6.1 Town Planning Reports

6.1.1 28 Beaconsfield-Emerald Road, Beaconsfield Upper

That Council issue a Notice of Decision to Grant Planning Permit T210780 for a three (3) lot subdivision and removal of native vegetation at 28 Beaconsfield – Emerald Road, Beaconsfield Upper 3808 subject to the following conditions:

Figure 3 - Proposed plan of subdivision, prepared by Brian Watson Surveying (Version 4).

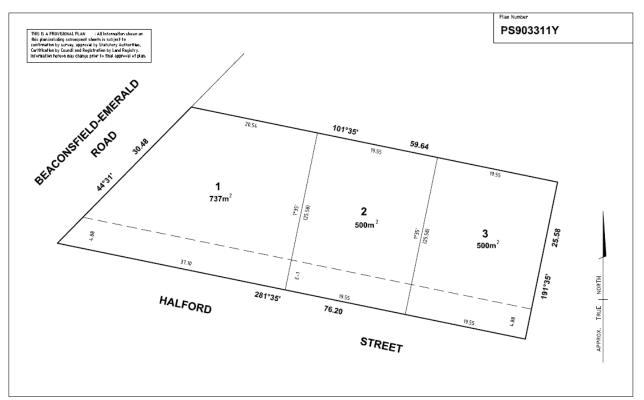
- 1. Before the plan of subdivision is certified under the Subdivision Act 1988, amended plans to the satisfaction of the Responsible Authority must be submitted to and approved by the Responsible Authority. When approved, the plans will form part of the permit. The plans must be drawn to scale with dimensions. The plans must be generally in accordance with the plans submitted with the application prepared by Brian Watson Surveying, Version 4 but modified to show:

- a. A 2.0m wide drainage easement, in favour of Council, aligned along the northern boundaries of Lots 1 and 2, and extending 2.0m into Lot 3 to allow lots to drain and connect to Council's existing drainage network at the western boundary

- b. Location of minimum width 3.5m crossover to Lot 2 and 3, extending to minimum width 4.7m at the edge of the road, and associated amendments to the Arborist Report and associated assessment of impacts to TPZ/SRZ. If required, alternate construction methods must be advised within the contents of the Arborist Report.

- c. An amended Bushfire Management Plan to reflect consistency of lot sizes and dimensions in accordance with the proposed Plan of Subdivision (Version 4).

Figure 5 - Plan identifying location of trees with proposed crossover locations shown in grey (Bluegum Consultancy, 15/02/2022)

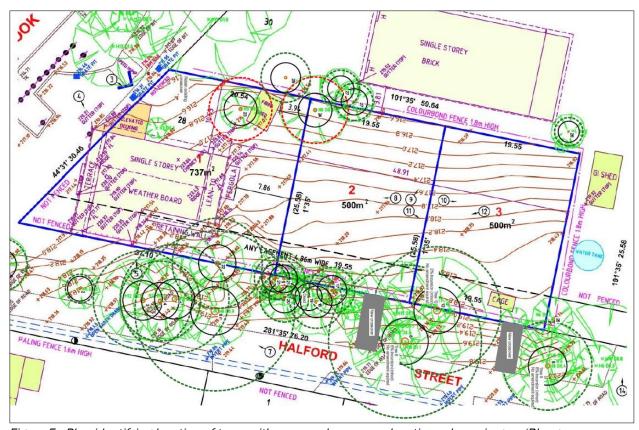
A total of 10 trees are proposed to be removed, inclusive of seven (7) trees (trees 7, 10, 11, 13, 14, 15, 16) within the Halford Street Road Reserve to accommodate proposed crossovers to service the subdivision. The remaining three (3) trees to be removed (Trees 23, 24, 25) are located within the subject site. These trees vary in specimen, age, condition, life expectancy and retention value, and it is noted not all trees proposed to be removed require a planning permit.
